Acube Portable Mother Board Bring-up Technical Report

Version: 1.0

Date: 05/04/2025

This document summarizes the findings from the analysis of the bring-up process of the “Acube Portable” board (*the board*). *The board* is a custom system built around the NXP QorIQ T2080, a 4-core PowerPC64 CPU. Several errors were discovered during the schematic review. The system was able to partially boot, but not to a usable state.

Figure 3: Board PORESET sequence

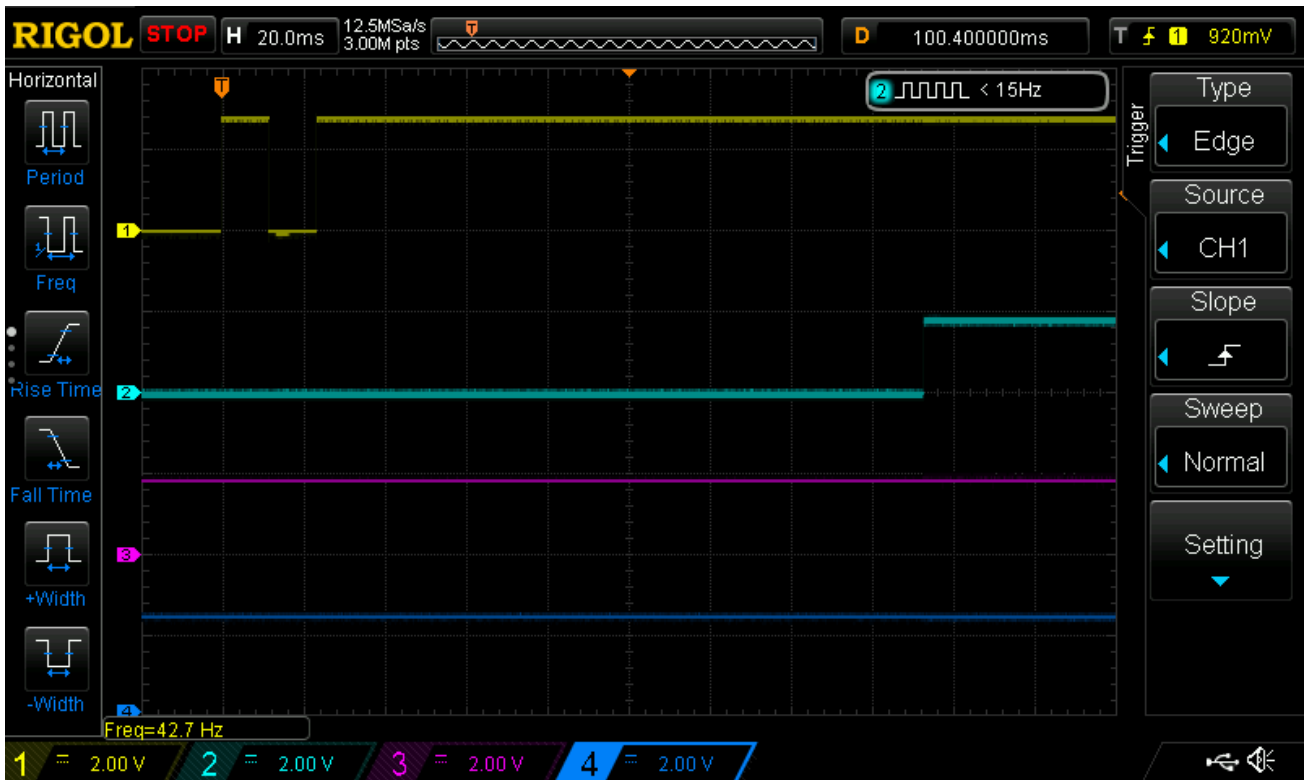
The board meets the required assertion time of at least one 1ms for PORESET_B, as seen in figure 3.

Figure 4: T2080RDB PORESET sequence

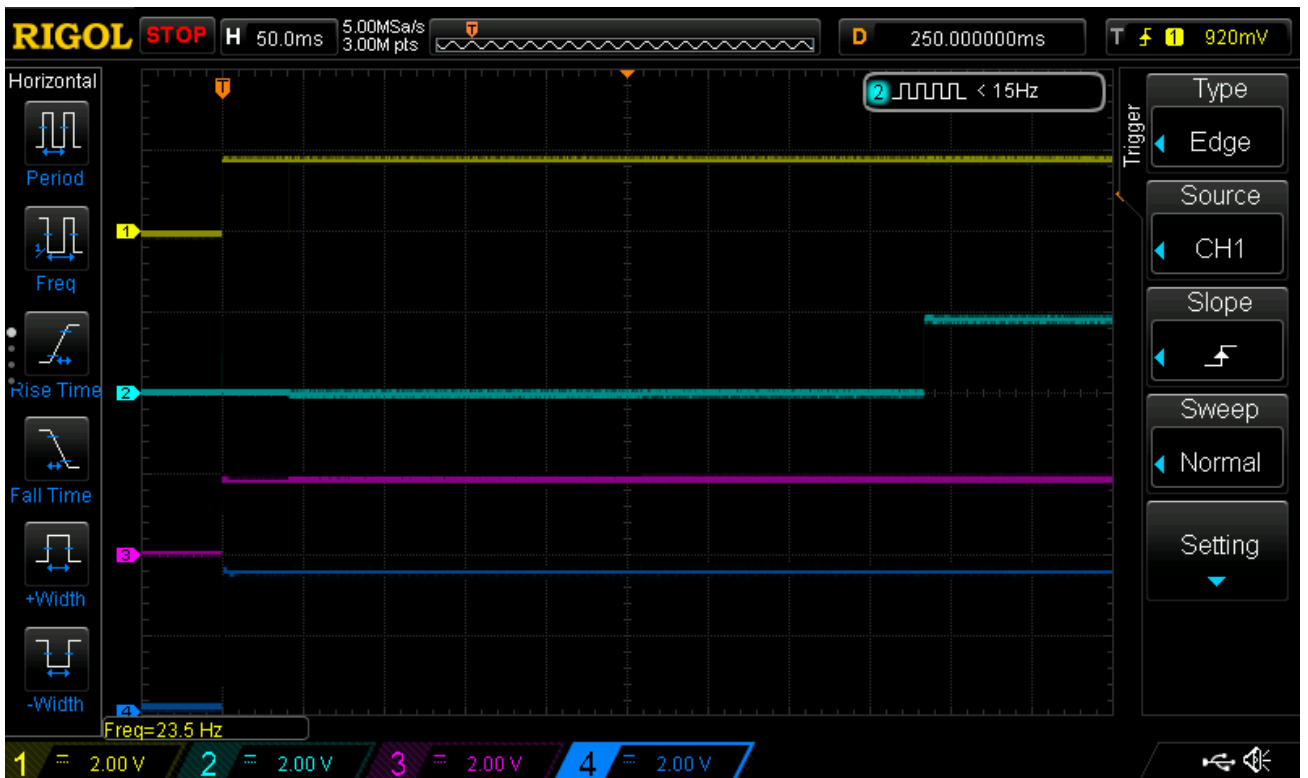
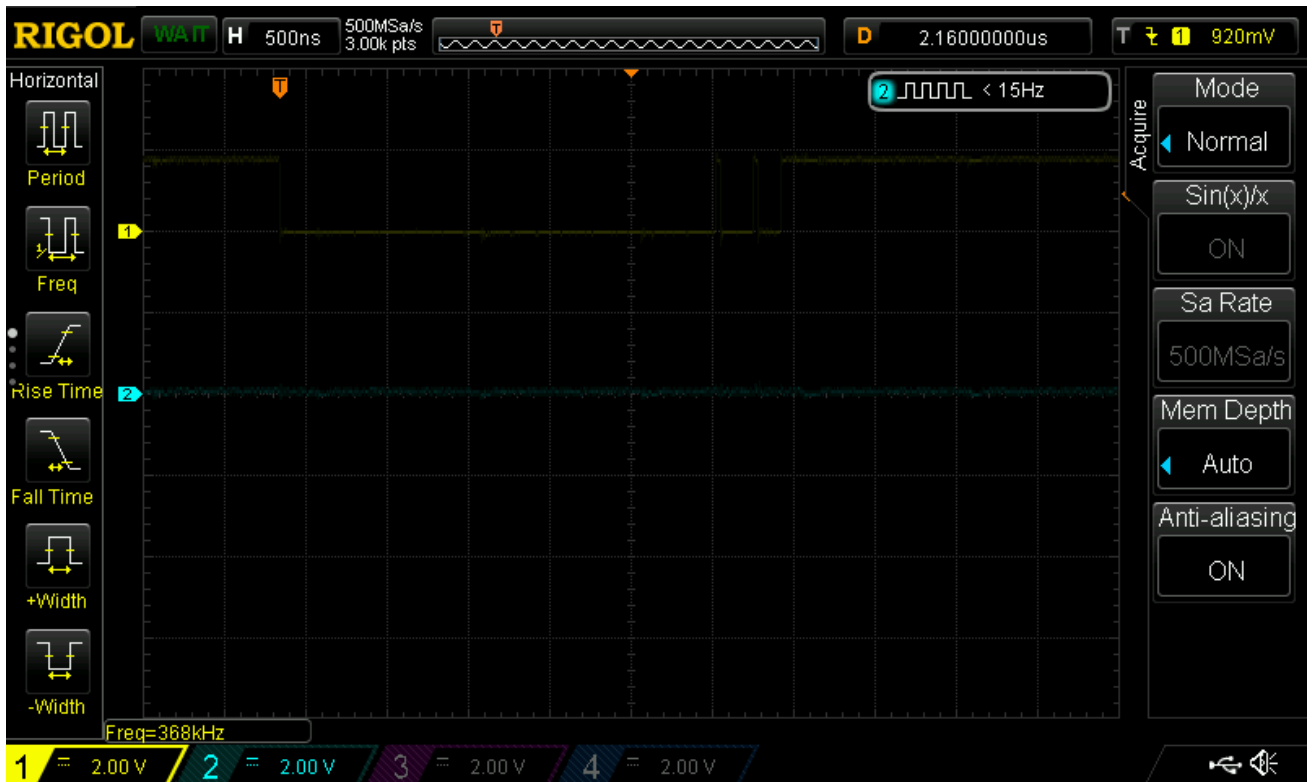
However, the T2080RDB shows a spike ~40ms after trigger, with an assertion time of only ~225ns, as shown in figure 4 with a detailed view in figure 5.
